SUBJECT: FORT CALHOUN STATION, UNIT NO. 1 - ISSUANCE OF AMENDMENT
RE: EXTENDING PRESSURE-TEMPERATURE (P-T) LIMITS (TAC NO.
MB0322)

Amendment No. 197
License No. DPR-40

SAFETY EVALUATION BY THE OFFICE OF NUCLEAR REACTOR REGULATION
RELATED TO AMENDMENT NO. 197 TO FACILITY OPERATING LICENSE NO. DPR-40
OMAHA PUBLIC POWER DISTRICT
FORT CALHOUN STATION, UNIT NO. 1
DOCKET NO. 50-285

Figure 2-1A

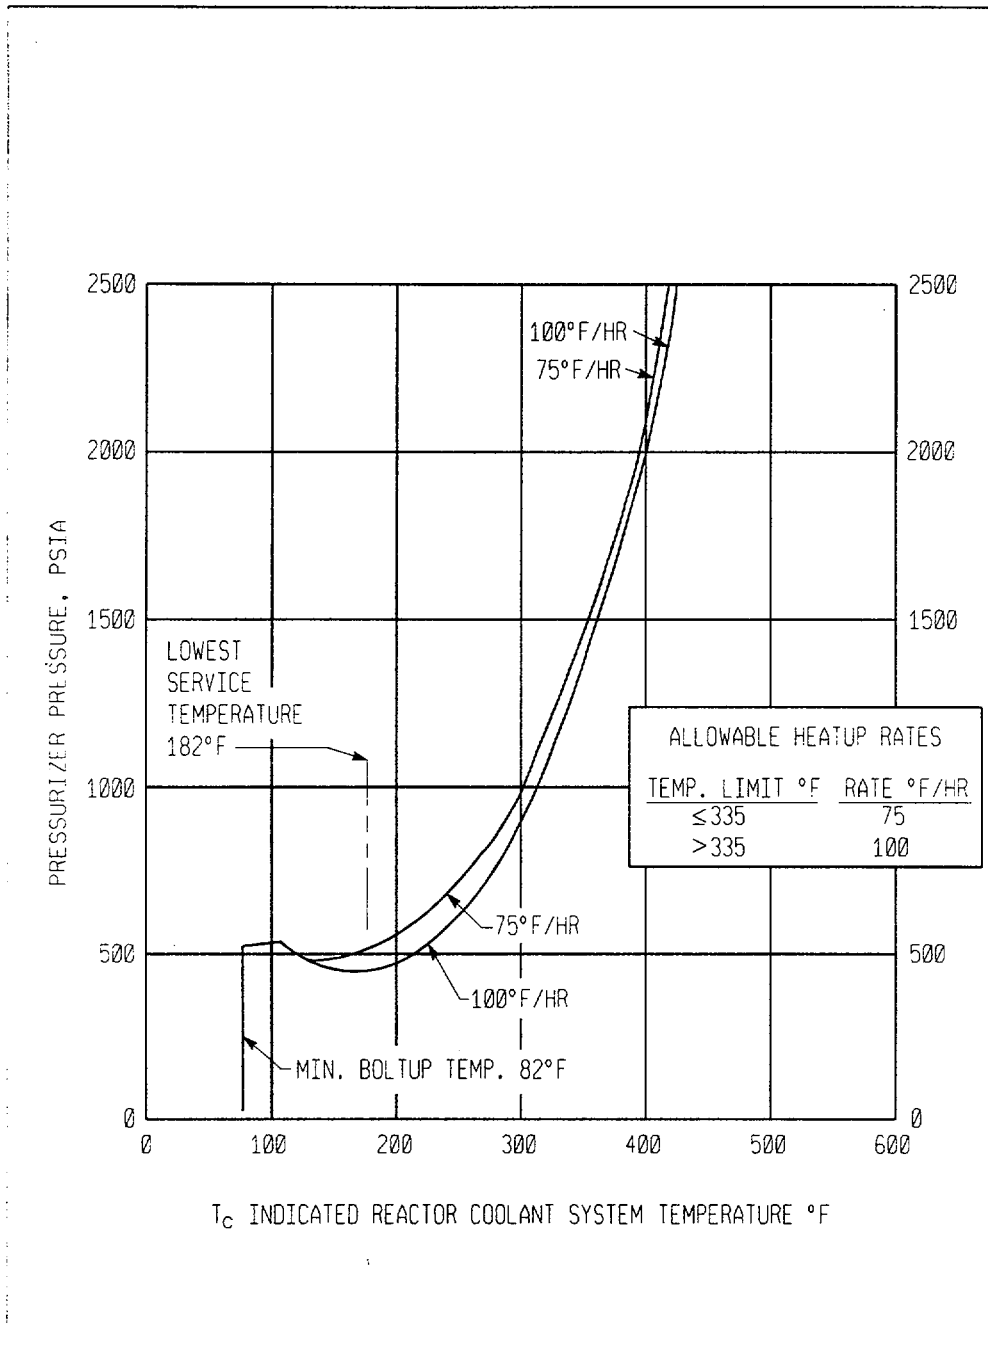
The amendment revises Section 2.1.2, Figures 2-1A and 2-1B, and associated Bases of the Fort Calhoun Station Technical Specifications to extend existing pressure-temperature (P-T) curves from 20 effective full power years (EFPY) to 24.25 EFPY. Additionally, the amendment deletes Figure 2-3, "Predicted Radiation Induced NDTT Shift" and updates the fluence analysis for projecting RT_{NDT} at 24.25 EFPY.

- In TS 2.1.2, Figures 2-1A and 2-1B, the EFPYs are changed from 20 to 24.25.
- Figure 2-3 in TS 2.1.2 is deleted because the new fuel management scheme renders it obsolete.

- (a) Figures 2-1A and 2-1B are valid for a fast neutron ($E \geq 1\text{MeV}$) fluence of $1.50 \times 10^{19} \text{ n/cm}^2$ which corresponds to 24.25 EFPY.

- (c) The limit lines in Figures 2-1A and 2-1B shall be moved parallel to the temperature axis (horizontal) in the direction of increasing temperature a distance equivalent to the transition temperature shift during the period since the curves were last constructed. The boltup temperature limit line shall remain at 82°F as it is set by the NDTT of the reactor vessel flange and not subject to fast neutron flux. The lowest service temperature shall remain at 182°F because components related to this temperature are also not subject to fast neutron flux.
